Hume Amendment C207 Sunbury South PSP

Expert Evidence – Traffic and Transport

11 August 2017

Figure 4-2 Sunbury South PSP – Exhibited Street Network

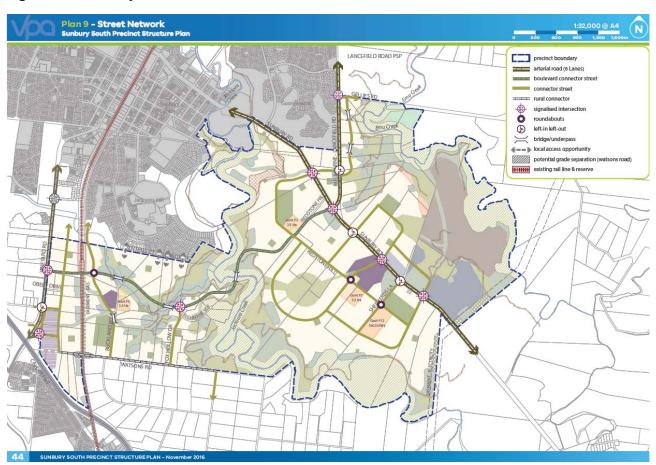
Item 6	Sunbury South PSP Plan 9	Amend the exhibited Street Network Plan (PSP Plan 9) to indicate a roundabout at the intersection of the Boulevard Connector / Northern Connector (located to the south-west of IN-03).	
		Also, amend Plan 9 to show a southern connection from the Francis Boulevard roundabout.

- > The alignment shown on the Cardno plan attached at Appendix A5 should be adopted;
- > The Boulevard Connector / Northern Connector intersection (located to the southwest of IN-03) should be shown as a roundabout on Plan 9 (Street Network) of the PSP;

- > Consideration be given to amending the Boulevard Connector / Fox Hollow Drive intersection from signals to a roundabout treatment on Plan 9 (Street Network) of the PSP;

- > A connection to the Francis Boulevard roundabout should be shown on Plan 9 (Street Network) of the PSP (potentially with an arrow to indicate a local street connection), to ensure a reasonable level of connectivity is provided to the arterial road network for residents in the north-western part of the site;
- > Given the hierarchy of Francis Boulevard, it would be reasonable to expect VicRoads to fund and upgrade the existing intersection to a signalised treatment as part of the duplication of Sunbury Road; and
- > The connection of a local street to the intersection as a fourth leg should be funded by Capitol Property outside of the future ICP, noting the topography of the land limits access to a relatively small catchment.

Figure 7-1 Exhibited Sunbury Road Cross-Section - Option 1

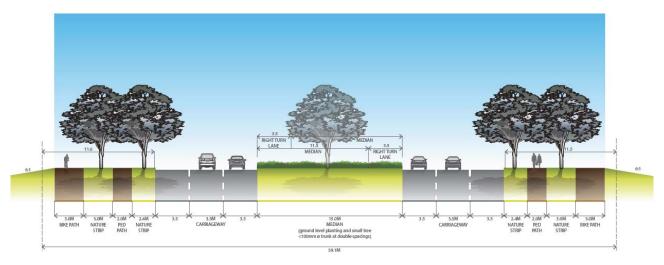
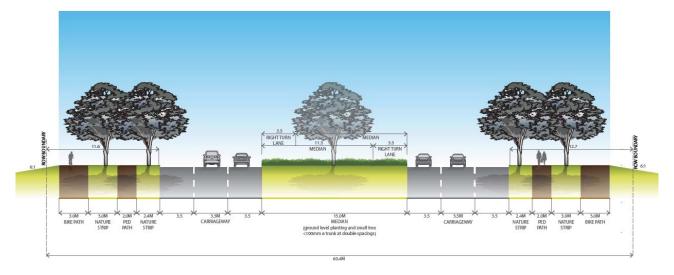
Aside from its transport function, Sunbury Road will need to accommodate a number of services within the verges and median.

It is noted that the number of services and position of the existing carriageway varies along the length of Sunbury Road and consequently it would be reasonable to expect that the required verge and median widths to accommodate these services will also change at different sections along Sunbury Road. Variations to the standard cross-section will also be required at bends to ensure appropriate design radii are provided.

Due to the central position of the existing carriageway, the alternative cross-section is off-centre with a shift of the carriageways towards the north-eastern side of the road compared to the exhibited cross-section.

I am of the opinion that it would be appropriate to amend the PSP cross-section to reflect the concept plans prepared by Mesh. To alleviate the need to produce multiple cross-sections it would seem more sensible to provide a single cross-section within the PSP, with the median and verge widths noted as variable.

Figure 9-1 Exhibited Concept Ultimate Alignment Plan – Sunbury Road / Lancefield Road (IN-03)

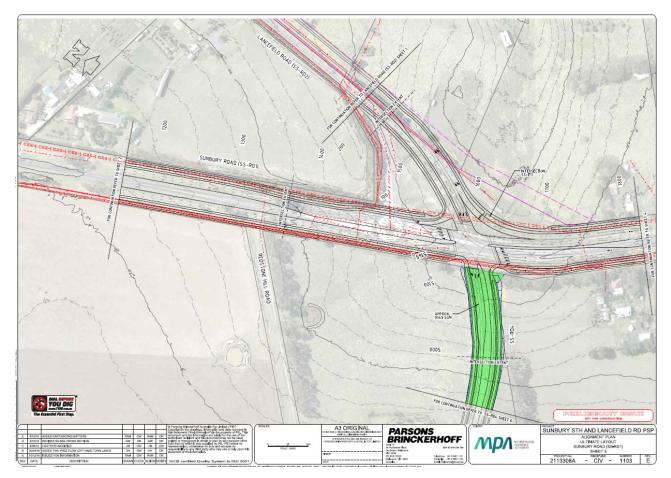
I understand that the Parsons Brinckerhoff plans repositioned the intersection on the basis that an 80 km/h design speed should be maintained on the northern leg of the intersection.

Alternative concept plans originally prepared by Traffix Group, and then modified by Ratio to reflect the alternative Sunbury Road cross-section discussed in Section 7, demonstrate an alternative alignment of the intersection in the same position as the previous roundabout.

Relevant sections of the exhibited PSP and future ICP should be updated to reflect this change.

Figure 9-3 Exhibited Concept Ultimate Alignment Plan – Sunbury Road / Francis Boulevard

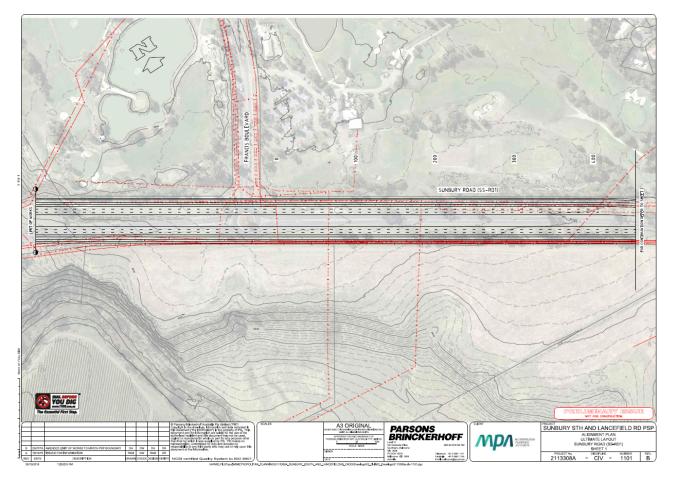
The exhibited Sunbury South PSP does not include any details on the future of the Sunbury Road / Francis Boulevard intersection that is located near the northern extent of the PSP.

Francis Boulevard is categorised as a connector street under Hume City Council's Road Register, and provides a north-south connection through Goonawarra Estate.

The concept site layout of Capitol Properties site considers a local street connection to the intersection. Due to the topography of the land, the proposed connection would only serve a relatively small catchment, and as such, the hierarchy of this road could be considered equivalent to a 'local street'. I consider that this connection to the roundabout is highly desirable to provide a reasonable level of connectivity for the residents in the western portion of the site. Without this connection, residents would have to circulate through approximately 1km of local streets to enter / exit the site via the IN-04 intersection.

- > Plans 9 (Street Network) and 10 (Public Transport and Path Network) of the exhibited Sunbury South PSP be amended to show a signalised intersection as the ultimate treatment at Sunbury Road / Francis Boulevard;
- Interim access to the existing roundabout be permitted to ensure that the constrained land pocket on the south side of Sunbury Road is able to be developed in an efficient manner; and
